Report to: Development Services Committee

SUBJECT: PRELIMINARY REPORT
Applications for Official Plan Amendment, Draft Plan of
Subdivision, Zoning By-law Amendment, Plan of
Condominium and Site Plan Approval by Gemterra
(Woodbine) Inc. to permit townhouses at 9064 to 9110
Woodbine Avenue (Ward 2)
File Nos. OP/SU/ZA/CU/SC 17 153653

SITE PLAN

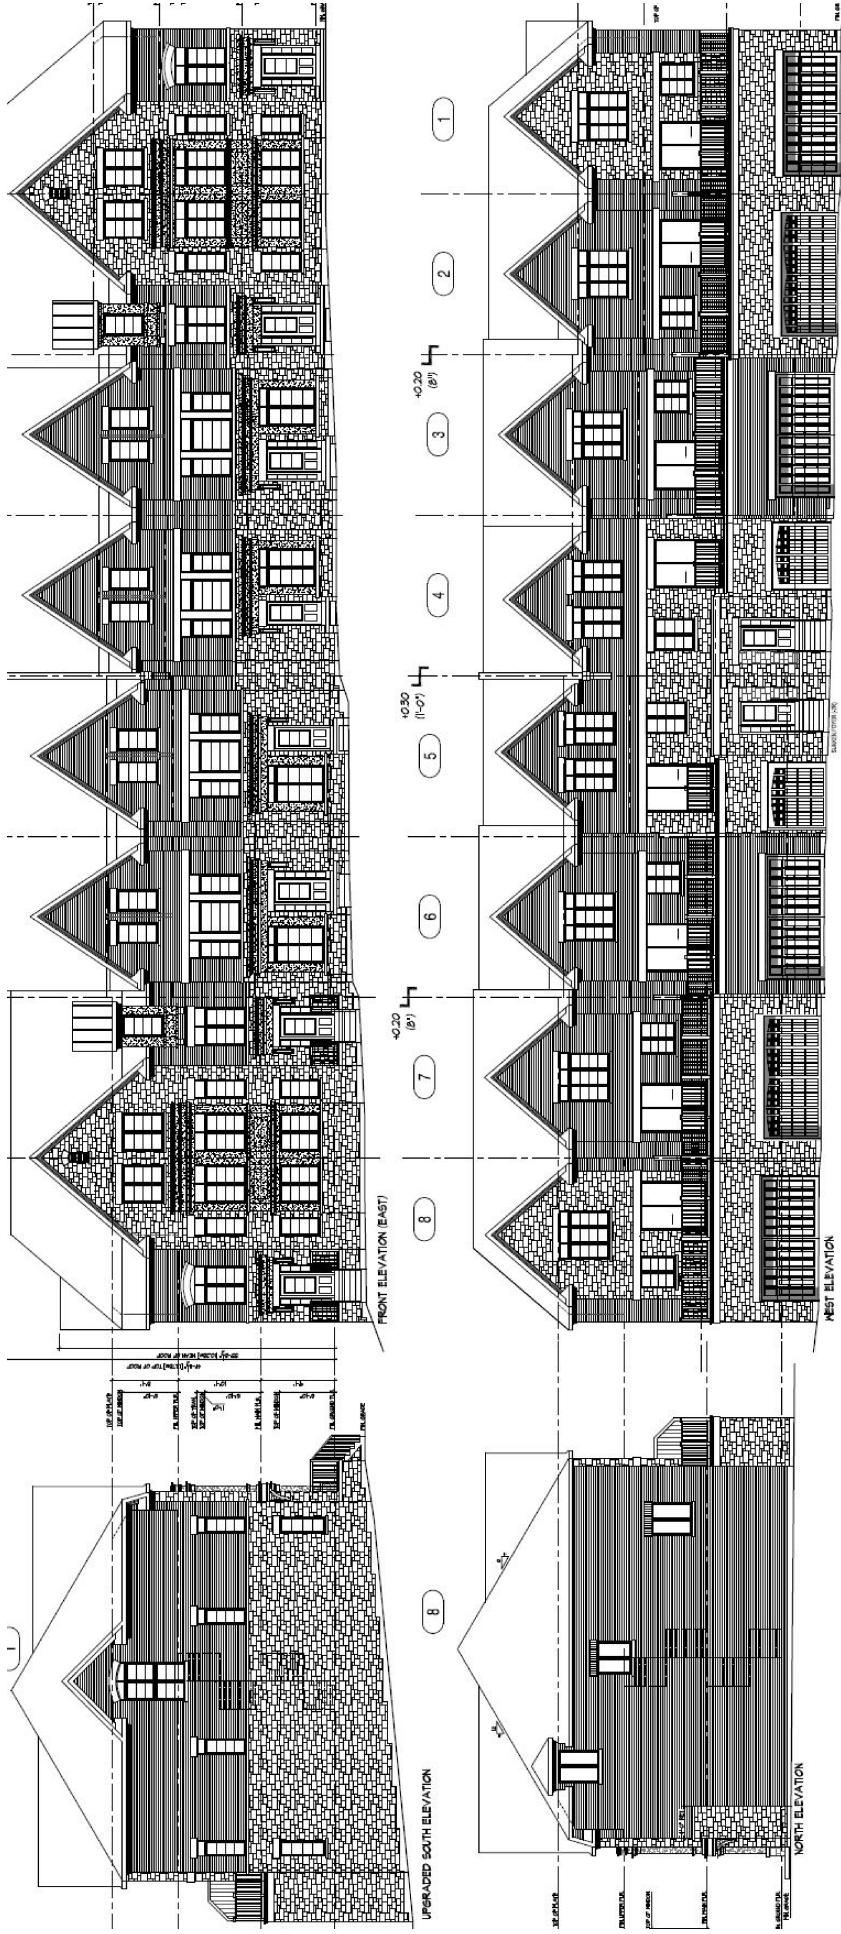
- a) Transportation Planning has advised that only one access to Woodbine Avenue, at the existing Millbrook Gate signalized intersection, will be permitted, whereas the site plan proposed a second access adjacent to the heritage dwelling.
- b) Conveyance of a road widening of Woodbine Avenue over the entire frontage. York Region is protecting for a 43.0 m right-of-way for this section and will require sufficient property to provide 18.0 m from the centerline of construction of Woodbine Avenue. This widening may affect the developable portion of the site.
- c) Conveyance of a 10.0 m by 10.0 m daylight triangle at the signalized intersection of Woodbine Avenue and the proposed full move access on to Woodbine Avenue.

- a) The proposed walkway at the north end of the property, between Woodbine Avenue and the valley lands to the west, should provide for a public connection to a future trail system, which is planned within the buffer.

- b) The Draft Plan of Condominium common elements should include the private road, amenity area, the front yards of the proposed townhouses fronting on to Woodbine Avenue for maintenance purposes, and a minimum 3.0 m wide access between townhouse Blocks to the satisfaction of the Fire Department.

- d) A minimum 10.0 m environmental buffer from the natural heritage feature is required. The Official Plan requires this buffer to be conveyed into public ownership. The site plan shows encroachments into this 10 m buffer by the rear

yards of the proposed townhouses in Blocks 3 and 4. Staff are continuing to work with the proponent to explore options of a reduced buffer.

- e) Some of the proposed driveways of units facing Woodbine Avenue (garage and driveways face the private lane) are approximately 4.5 m long. This length is insufficient for a parking space. Consequently, vehicles parked on these driveways could obstruct the internal fire route along the private lane. The proponent is aware of this concern and is exploring options to change the length of those driveways.

- f) The proposed townhouses, fronting Woodbine Avenue, have double car garage widths that dominate the entire portion of the building facing the lane. This will create an undesirable back-lane character for the units on the west side of the private lane. The proponent and staff are exploring options to mitigate this concern.

- a) A minimum 3.0 m fire break is required between Blocks 1 and Block 2 to provide emergency access from Woodbine Avenue to the proposed private road.
- b) A second entrance is required on to Woodbine Avenue, unless all of the proposed townhouse buildings are sprinklered.

- a) The Operations Department noted that the proposed site plan does not show snow storage areas.
